NINE MILE POINT  
NUCLEAR STATION

**SUBJECT:** Nine Mile Point Nuclear Station  
Unit No. 2; Docket No. 50-410

Response to Request for Additional Information Regarding Nine Mile Point Nuclear Station, Unit No. 2 – Re: The License Amendment Request for Extended Power Uprate Operation (TAC No. ME1476) – Spent Fuel Pool Criticality Analysis

Figure SFP-1 – Rack  $k_{inf}$  Versus Burnup for All Fuel Types in the NMP2 SFP at 4.95% Enrichment with No Credit for Gd

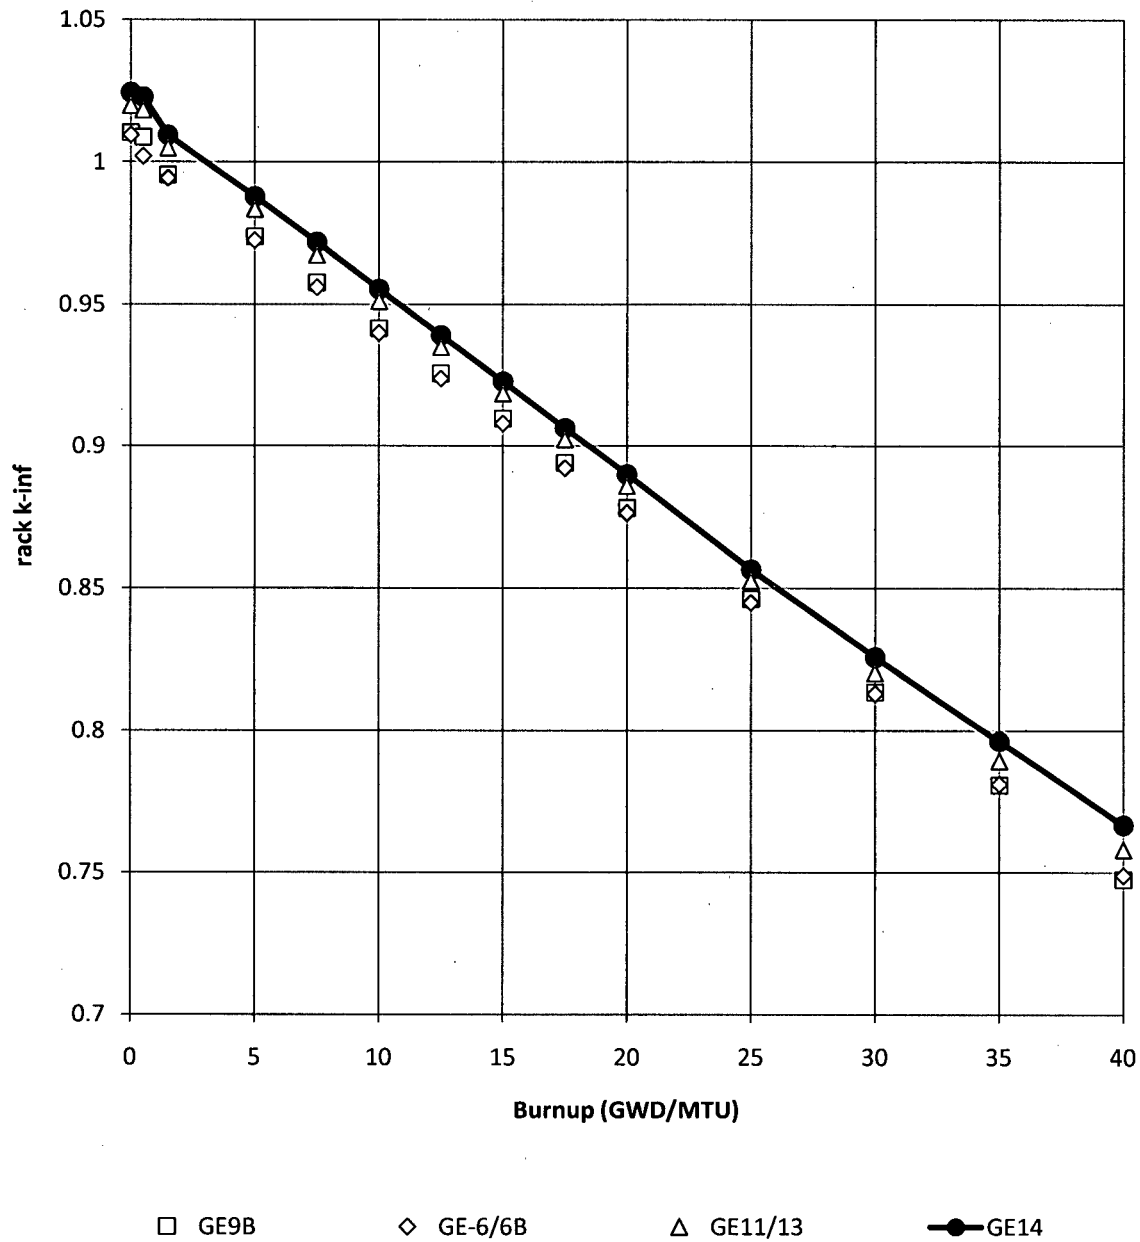
*addition, provide the quantitative information that shows that the most limiting GE14 lattice design analyzed for the EPU submittal bounds all fuel stored at NMP2. This information may include the comparisons of keff vs. burnup curves for the applicable lattice designs and the actual burnup values for the fuel bundles stored at NMP2. The NRC staff needs this information to make a reasonable assurance determination that NMP2 fuel storage racks complies with NMP2 Technical Specification Section 4.3, "Fuel Storage".*

credit for Gadolinium (Gd) to determine the k-infinity ( $k_{inf}$ ) in both the standard cold core geometry and the rack configuration for burnups ranging from 0 to 40 GWd/MTU (summarized in Figure SFP-1). Since GE11 and GE14 assemblies have partial length rods, they were evaluated both with and without a fuel rod in those locations. The GE14 assembly (with water in the part length rod location) was chosen as the bounding assembly on the basis that it had the highest rack  $k_{inf}$  at the burnup which yielded a  $k_{inf}$  of 1.32 in the standard cold core geometry (see Worksheet C.2 on page C-4 of the report). A depletion uncertainty equal to 5% of the largest reactivity decrement for any fuel type from fresh fuel to the above mentioned burnup was also determined and used for all assemblies. The bounding GE14 assembly was then used as the reference assembly in subsequent calculations to determine uncertainties from manufacturing tolerances (Boral B-10 loading uncertainty, 0.05 wt% enrichment uncertainty, etc), as well as the effects of various Gd loadings, moderator temperature changes, channel removal or bulging, eccentric fuel positions, abnormal fuel locations and accident conditions. The acceptance criteria used in the Holtec report was the Technical Specification 4.3.1.1.a requirement that k-effective ( $k_{eff}$ ) remain less than or equal to 0.95, including allowance for uncertainties, with the racks fully loaded with the most reactive fuel (GE14) in unborated water at the Technical Specification 4.3.1.1.b spent fuel storage rack cell pitch of 6.18 inches.

GE11 and GE14 are bounding results from partial length rods modeled as water and fuel.
